Access Compliance Report

Public Rights-of-Way

Intersection ID: 27715	Main Street: HAMPSHIRE_HILL_RD	Cross Street: OLD_ACRES_CT	Location: NE
ADA ID: 401B3BBF8DF0	Ramp Type: PerpDiag	Initial Pass/Fail: Pass	Overall Compliance: No
Severity Score: 0.25			
Codes/Mitigation Info/Possible Solution		Field Measurements/Component Compliance

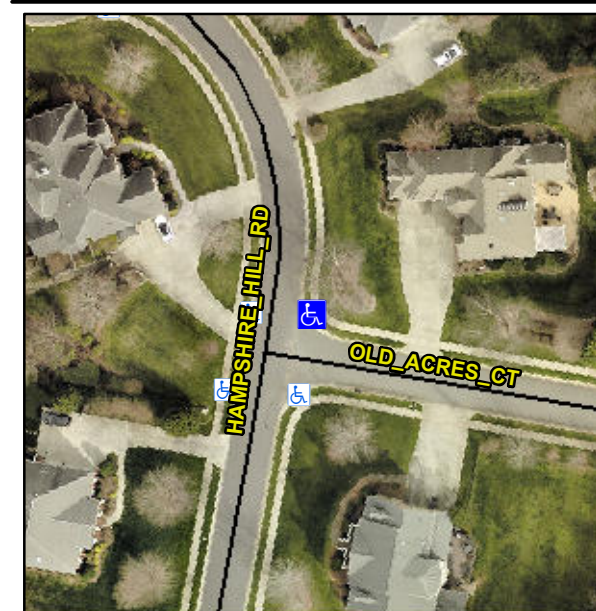
Not Found, R304.5.3, R304.2.2-Perp, R304.3.2-Para, R305.1.4, R305.2

Compliance	Description	Data	Compliance	Description	Data
N/A	Ramp Length (in)	48.0	Yes	Ramp Slope (%)	7.5
Yes	Ramp Width (in)	56.0	No	Ramp XSlope (%)	3.5
N/A	Flare Type LT	Sloped	N/A	Flare Type RT	N/A
N/A	Flare Slope LT (%)	2.5	N/A	Flare Slope RT (%)	7.2
N/A	Flare Traversable LT?	No	N/A	Flare Traversable RT?	No
Yes	Landing Length (in)	52.0	Yes	DWS Provided?	Yes
Yes	Landing Width (in)	56.0	Yes	DWS Contrast?	Yes
No	Landing Slope (%)	3.2	No	DWS Length (in)	23.5
No	Landing X Slope (%)	4.1	Yes	DWS Full Width?	Yes
N/A	Landing Curb? (Y/N)	No	No	DWS Offset (in)	6.0
N/A	Shared Landing?	No			
Yes	Gutter Ponding?	No	Yes	Gutter Slope (%)	1.8
Yes	Gutter Lip Ht (in)	0.0	No	Gutter X Slope (%)	4.4
N/A	Painted X Walk1?	No	N/A	Painted X Walk2?	No
	X Walk 1 Direction	To W		X Walk 2 Direction	To S
N/A	X Walk 1 Width (in)	N/A	N/A	X Walk 2 Width (in)	N/A
	X Walk 1 Slope (%)	2.5		X Walk 2 Slope (%)	2.2
	X Walk 1 X Slope (%)	1.5		X Walk 2 X Slope (%)	5.7

Remove & Replace Curb Ramp With Two New Directional Ramps or Equivalent. Remove & Replace Gutter.
